CHANGE ORDER

PROJECT: RIO QUEMADO WATERSHED PROJECT

CONTRACTOR: REINEKE CONSTRUCTION LLC
CHANGE ORDER NO: 2

PROJECT NO: 162646 / AGREEMENT NO. 2015-0143-PW/PL

GRADING PLAN: AT-GRADE CROSSING

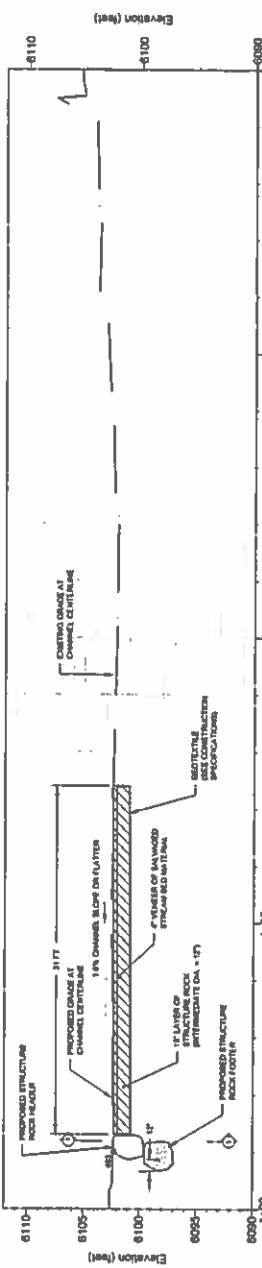
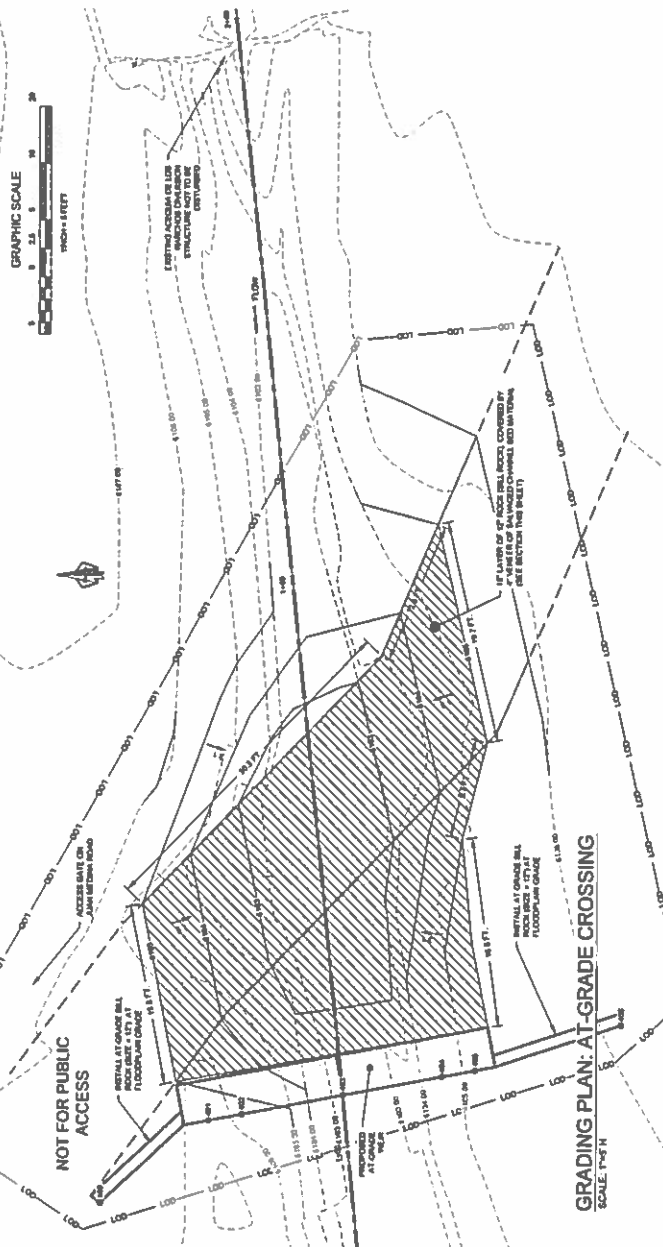
The Engineer initiated design changes to the Sra. Epitacio deAgüero Structure and the At-grade crossing structure, for the purpose of improving the value of the proposed stream stabilization structures on the Rio Quemado. It is also necessary to adjust some of the as-constructed quantities for Las Cuevas & Manuel Vigil Acequias as they are less than Contract quantities.

Sheet 4 – Grading Plan: At-Grade Crossing, revised 1/15/16;

CONSTRUCTION DETAILS

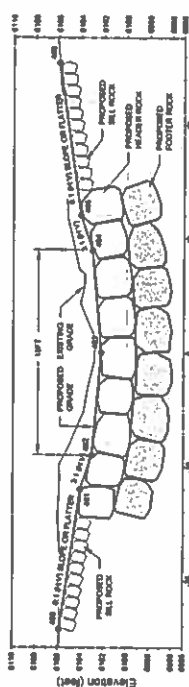
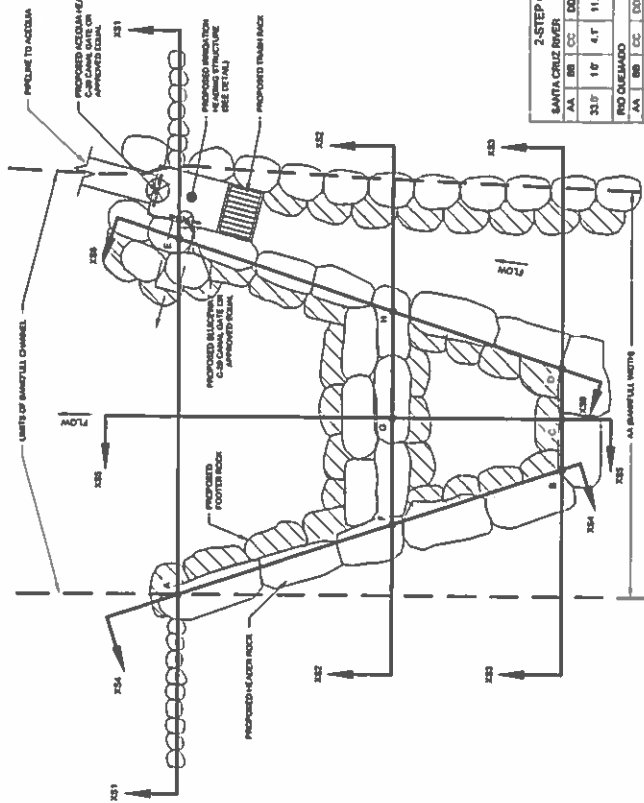
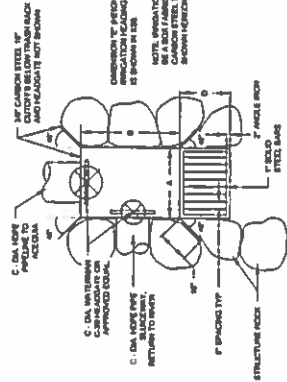
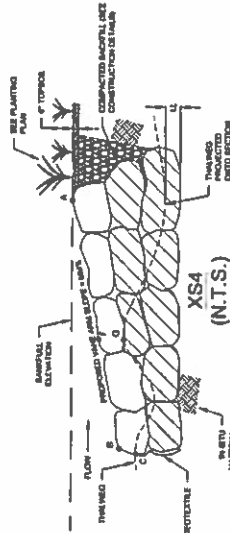
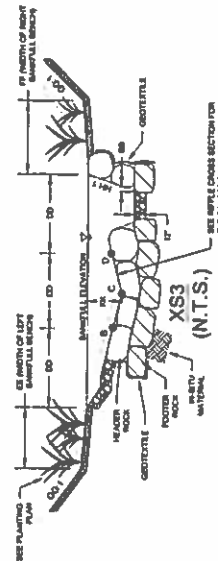
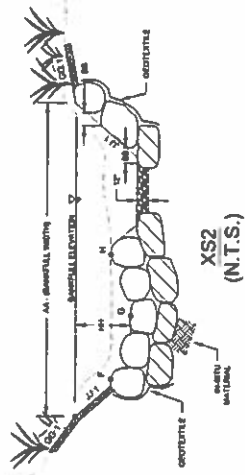
Sheet 6 – Construction Details, revised 1/15/16
